STAFF RECOMMENDATION

1900 Beechwood Avenue

September 16, 2020

Application: New Construction—Outbuilding; Setback Determination

SITE PLAN

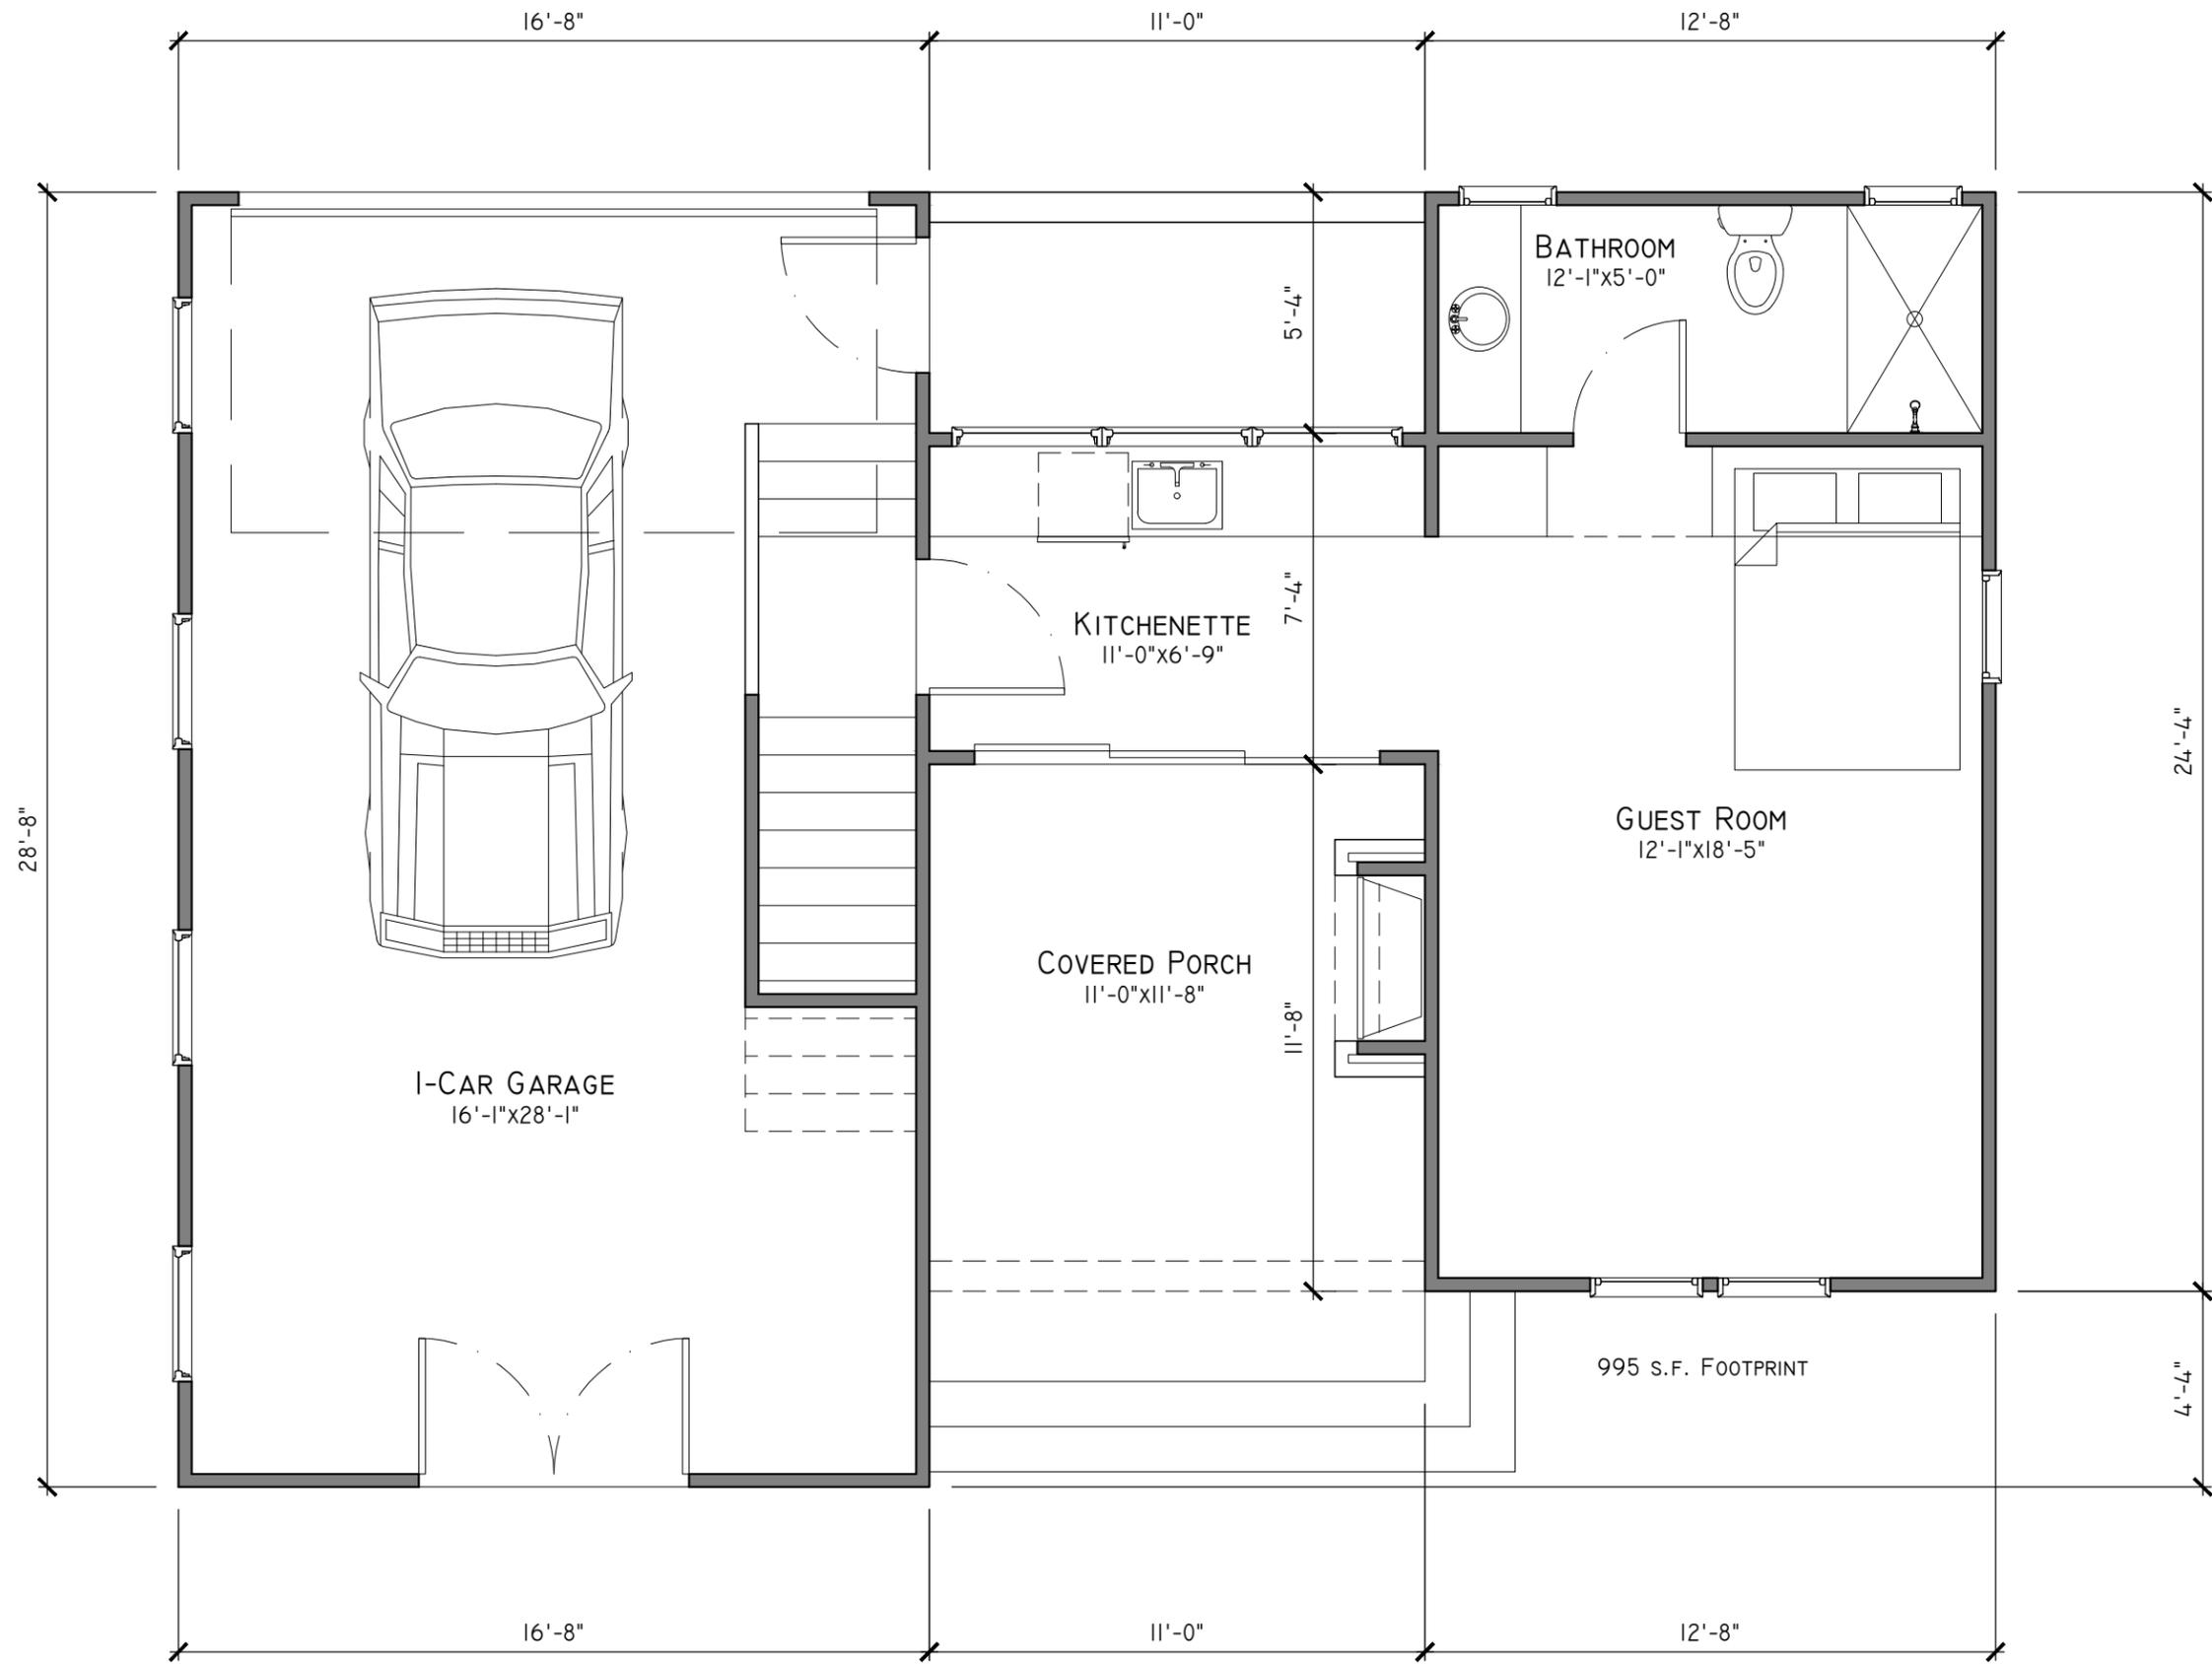
*There is an existing one-story outbuilding on the lot that does not meet the side-street and rear setback requirements. The addition to the outbuilding will also not meet the base zoning setback. Staff finds that the Altura Place setback of approximately three feet, eleven inches (3'11") to meet the design guidelines because this portion of the outbuilding is just one-story in height, and the existing footprint will only be increased by less than three feet (3'). In addition, the added depth will be added to the rear yard, towards the house, and will not affect the visibility along the alley.

On the alley, the width of the outbuilding will increase by about sixteen feet (16'), and the new portion will be two stories and will be just two feet, eleven inches from the rear property line. Because this part of the outbuilding includes a garage bay, is along a public alley, and is two-stories, staff recommends that the two-story portion of the structure be pushed back to meet the five foot (5') setback.

1. The two-story portion of the outbuilding be five feet (5') from the rear property line;
2. Staff approve all windows and doors, masonry samples, the roof shingle color, and the metal roof color and design prior to purchase and installation; and
3. The HVAC be located behind the house or on either side, beyond the mid-point of the house.

EXTERIOR ELEVATIONS

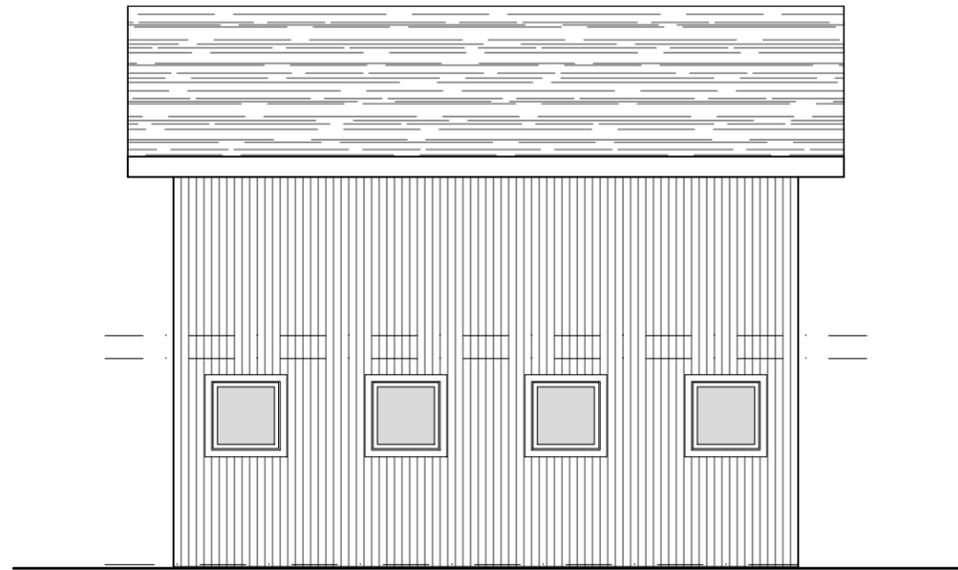
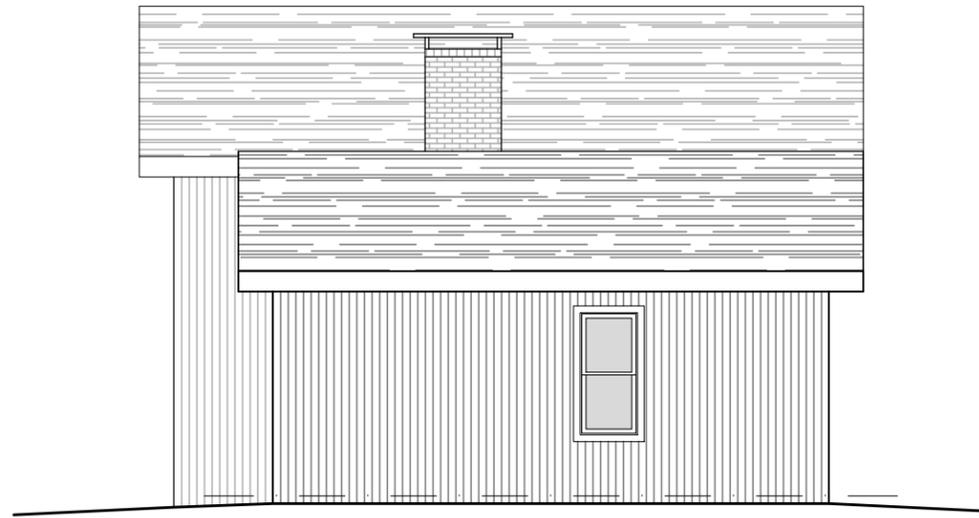
With staff's final approval of all materials, including the brick sample, roof material and color, windows, doors, and garage door for the outbuilding, staff finds that the materials meet the design guidelines.
